RE: Bethlehem Landfill Company
Northern Realignment
Amended Preliminary/Final
Land Development Plan, Site Plan and Lot Consolidation
Our file: b/1162.4/NR/LDP/102620

Bethlehem Landfill Company (“BLC”) hereby submits the following regarding the above referenced project, in response to a review letter issued by Hanover Engineering on September 17, 2020:

CADD FILE: 1162.4-PC-06.dwg
 DATE: 08/10/20
 SCALE: AS SHOWN
 DRAWING NO.

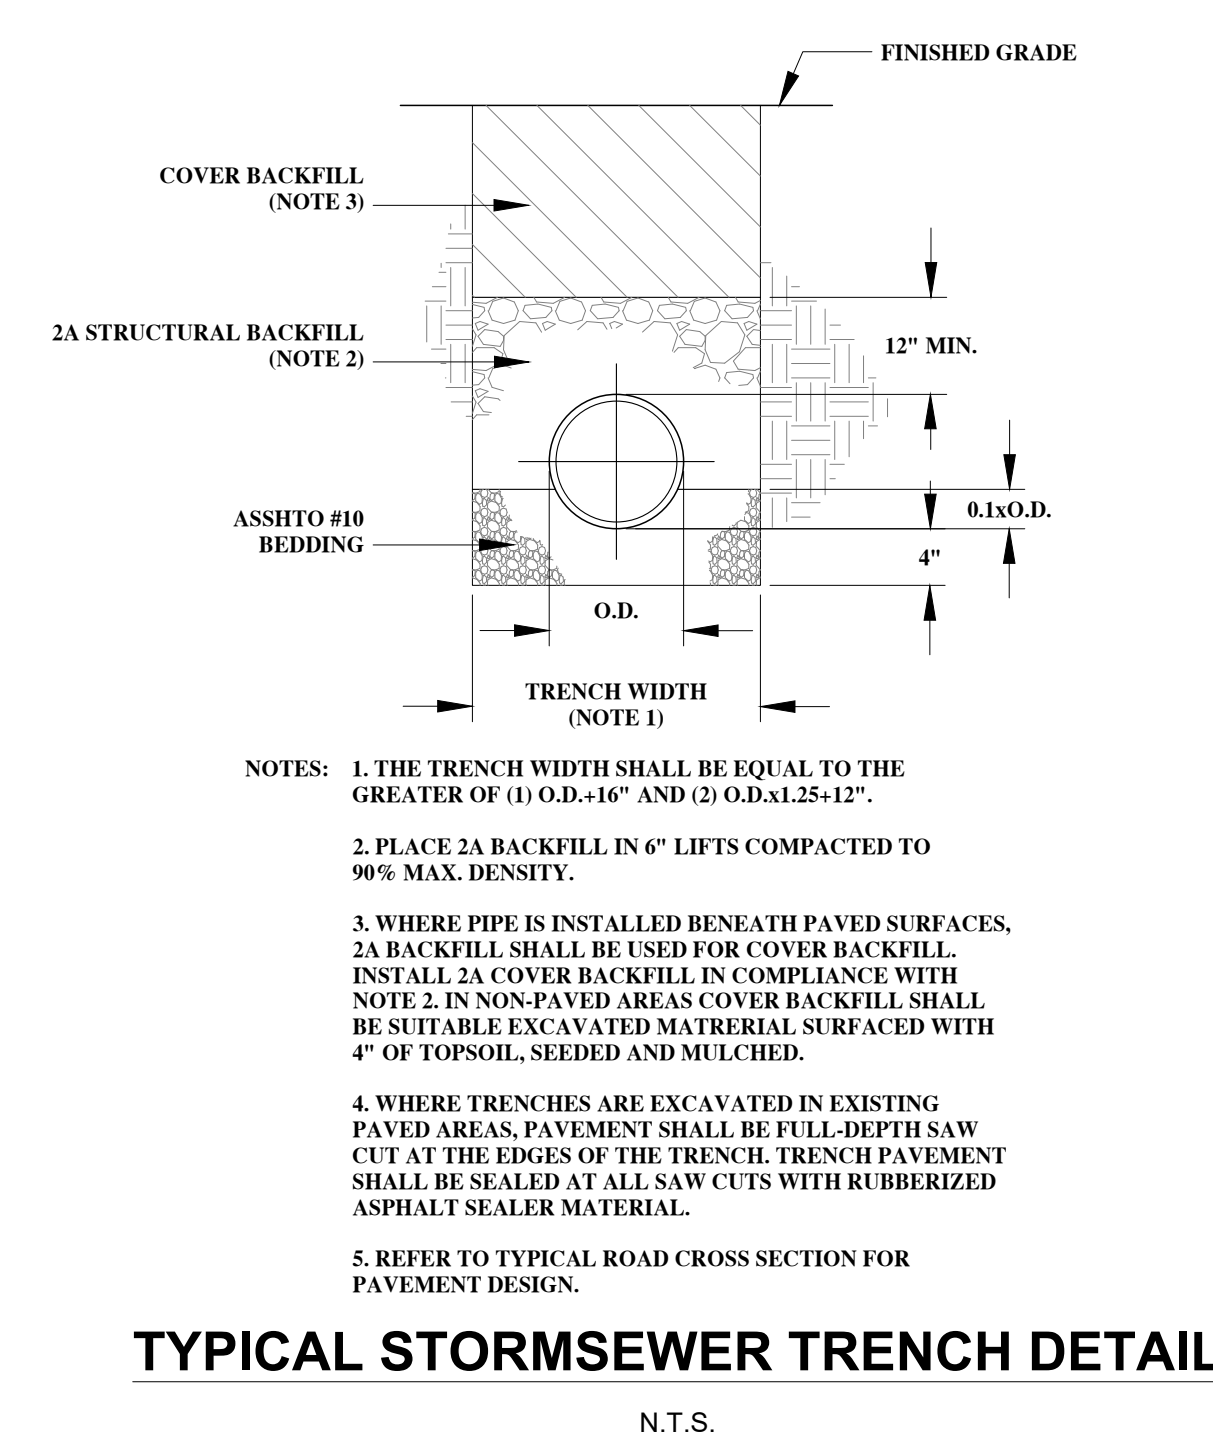
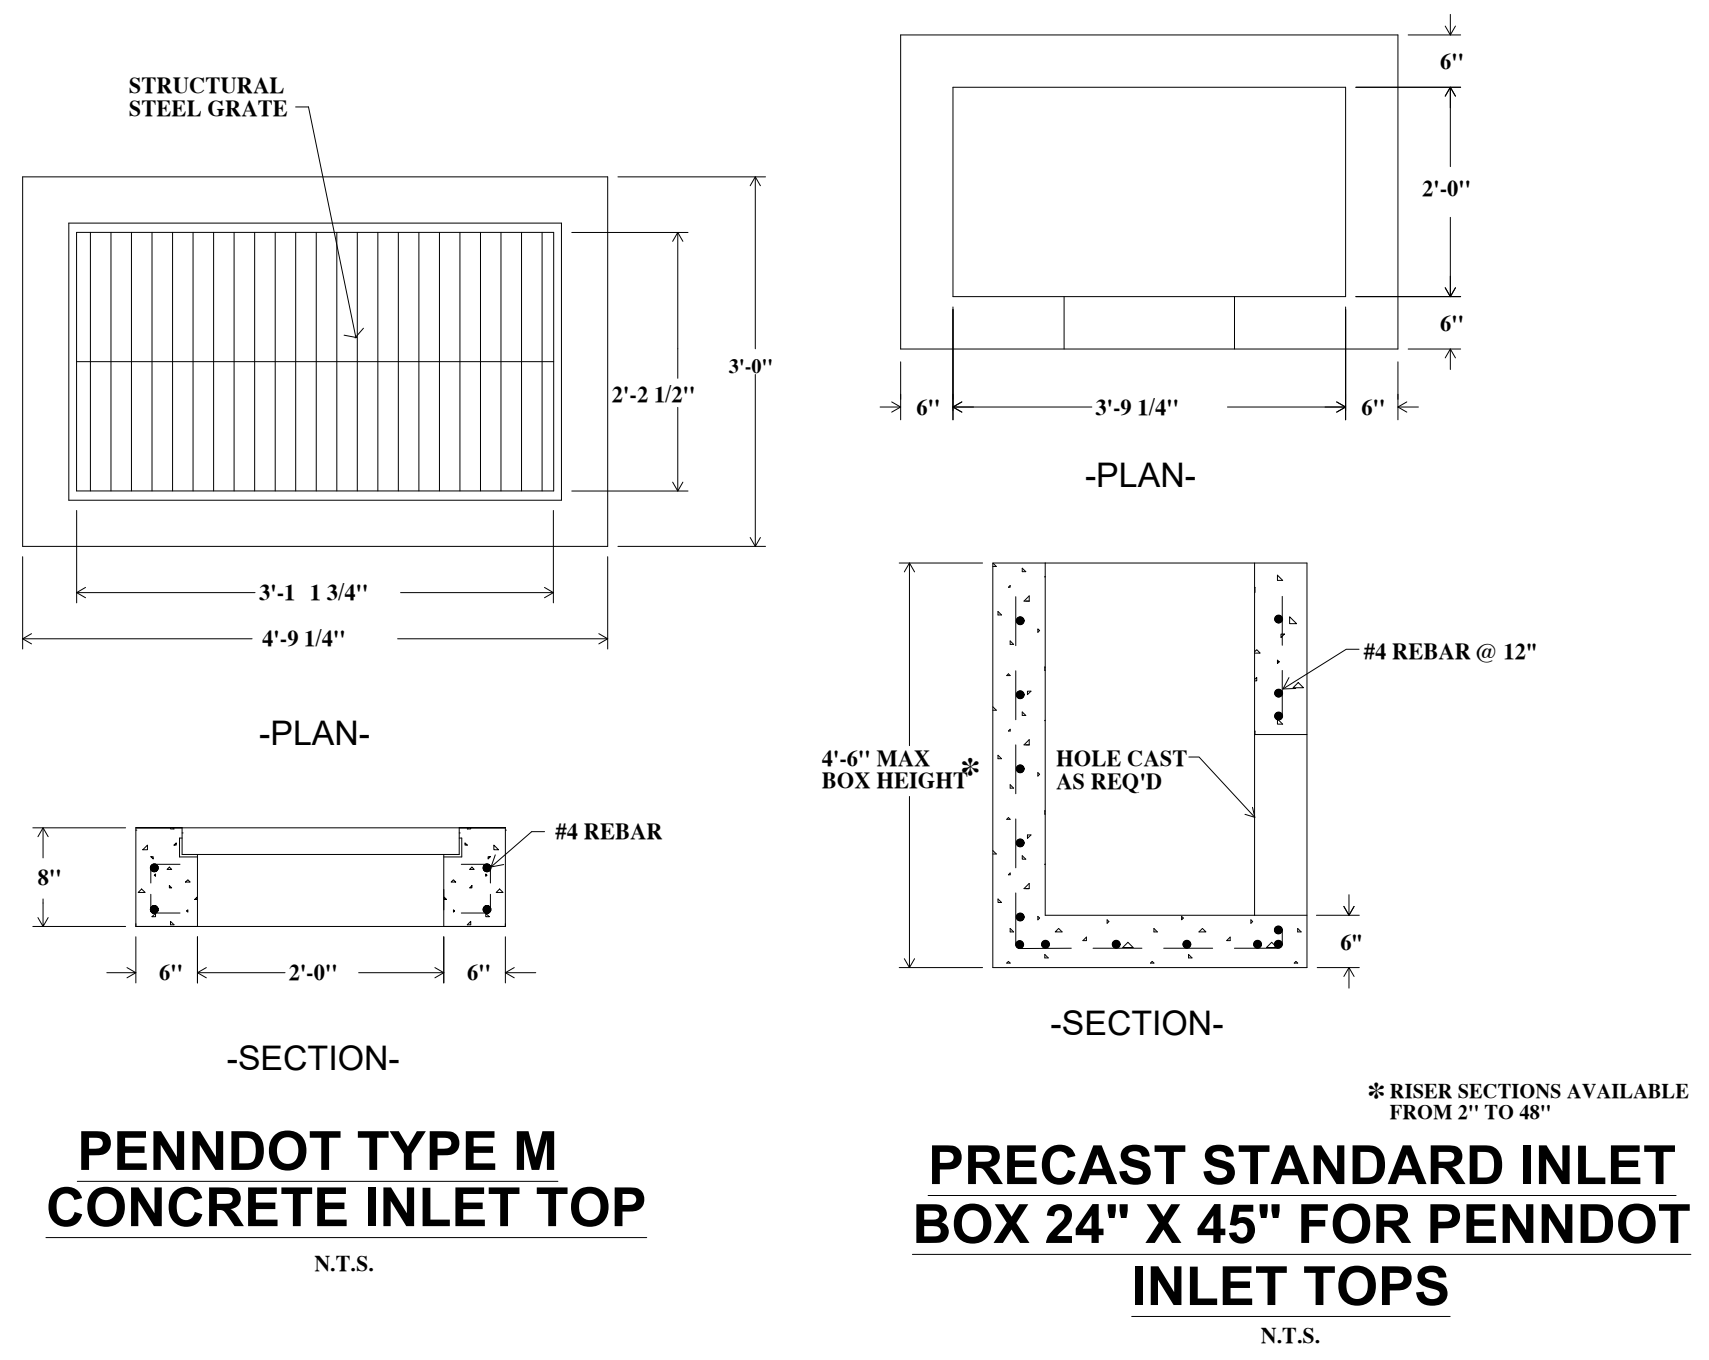
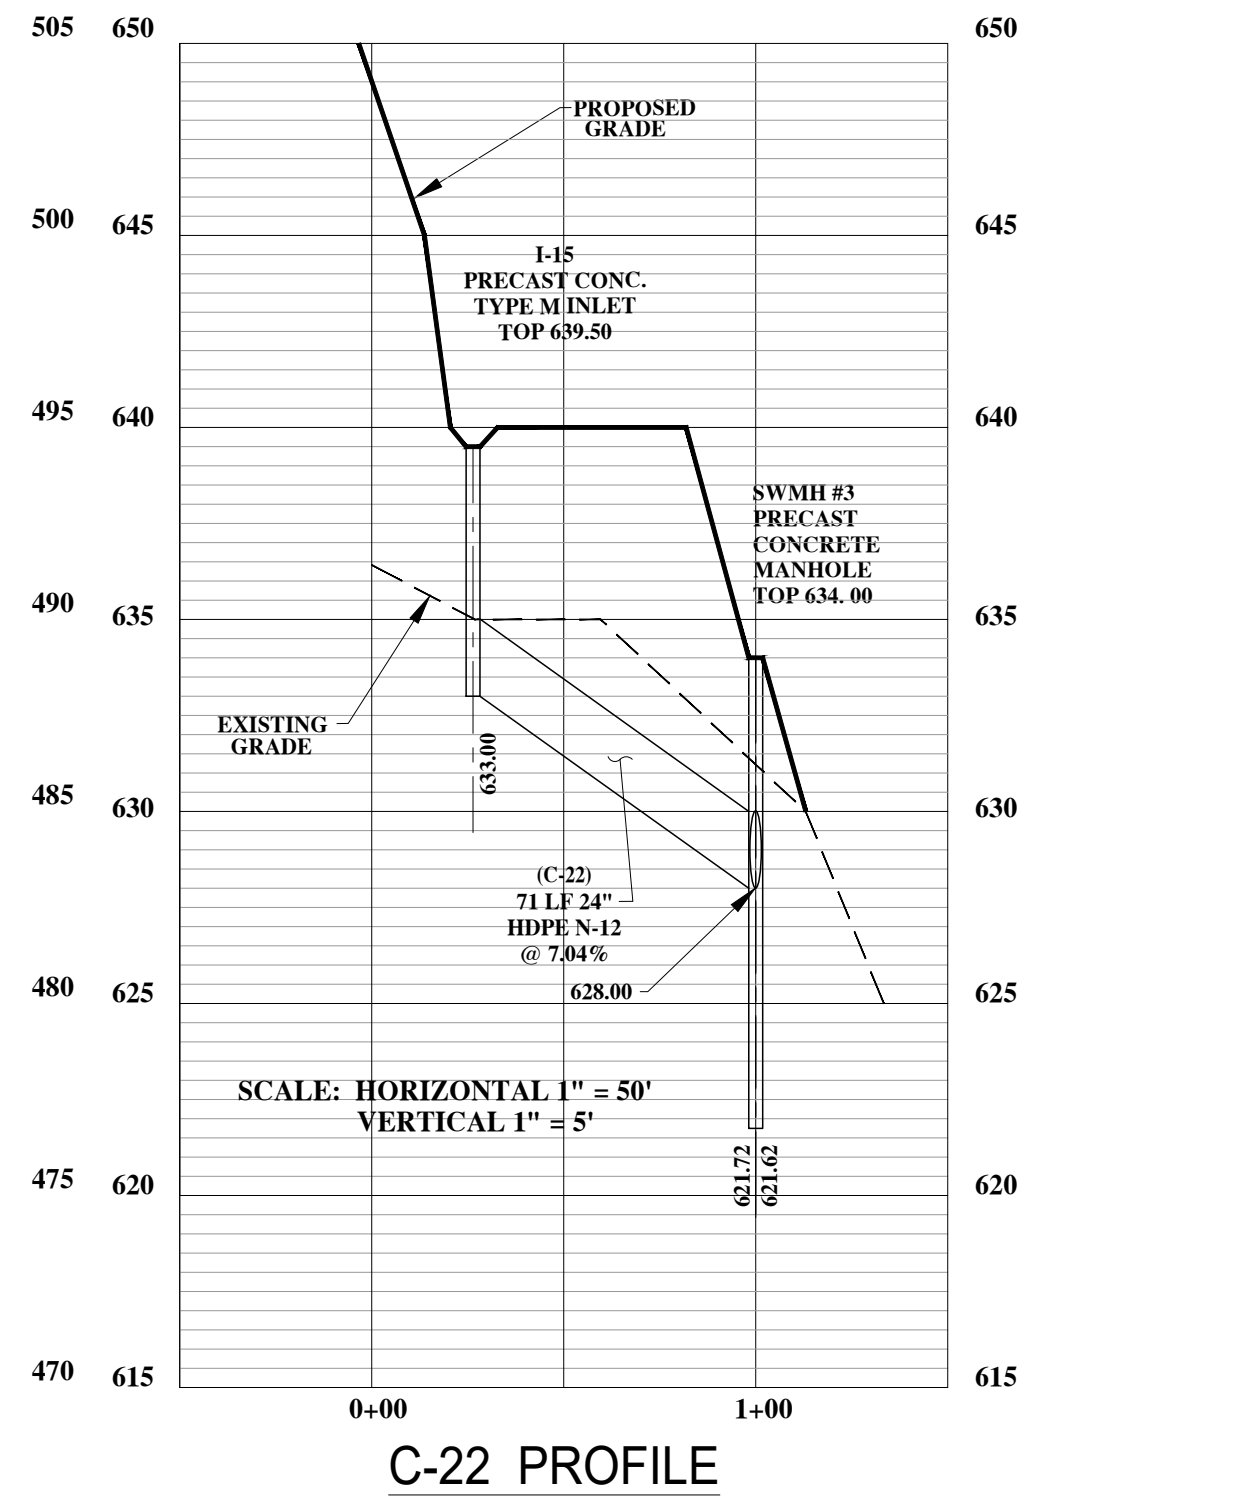
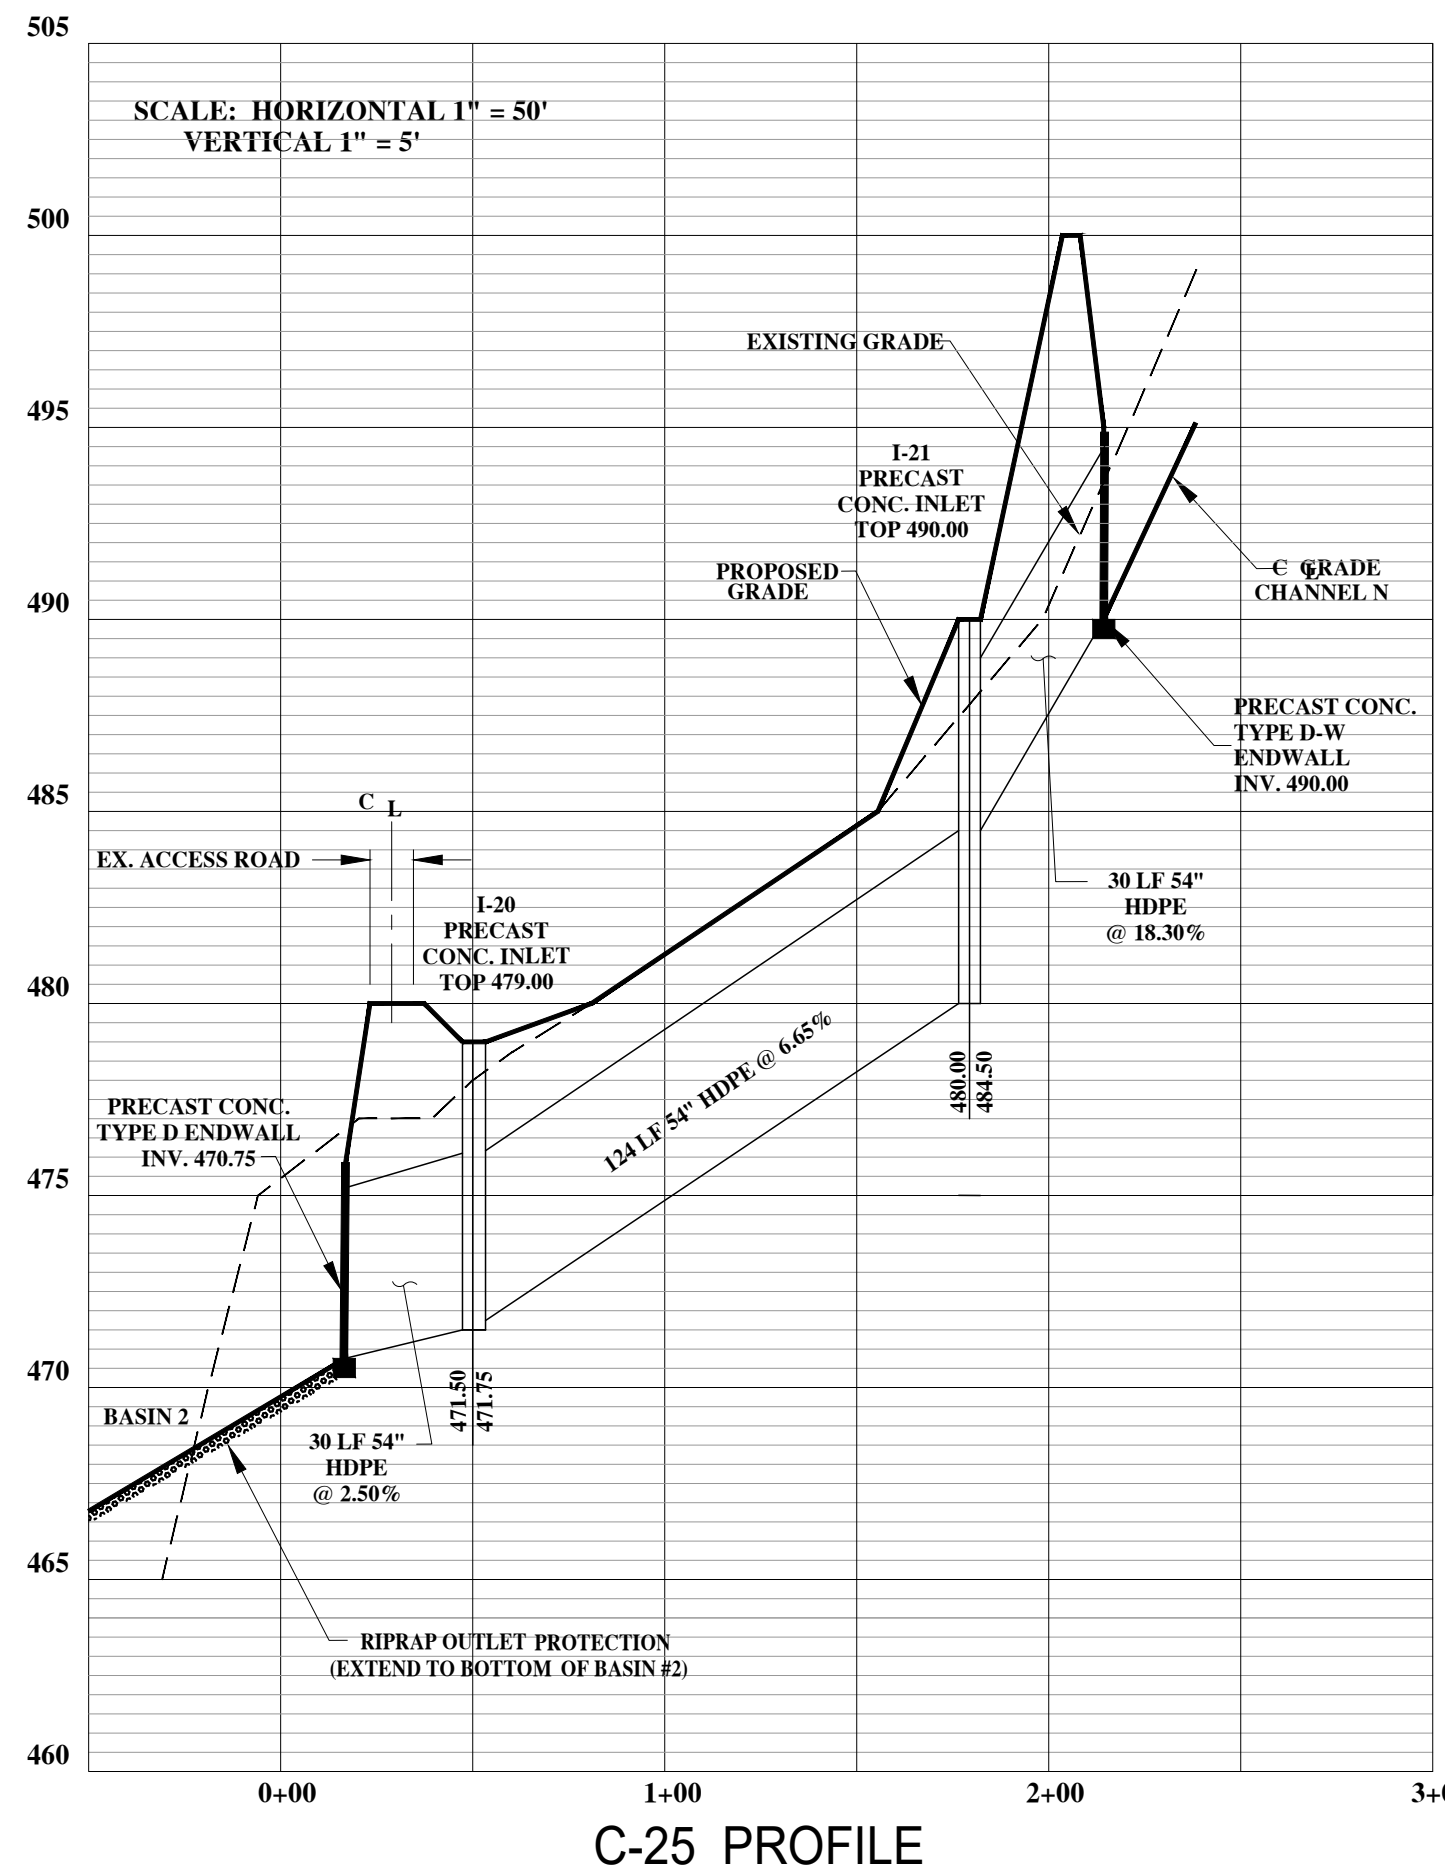
- f. The Channel N, Channel DS-7, Channel DS-8 and Channel DS-9 slopes listed/utilized in Appendix J and listed in the Summary Hydraulic Design of Permanent/Temporary Waterways chart on Sheet PC-6 shall be checked and revised accordingly, as different slopes are listed on Pages J-4,-7 and -8, utilized in the calculations and listed in the chart.

The slopes of all proposed channels have been checked and revised accordingly for consistency between the plans and the PCSM report contained within Section 10 of the Land Development Plan Supporting Documents Binder. Refer to Appendix J of the revised PCSM report and revised Plan Sheet PC-6.
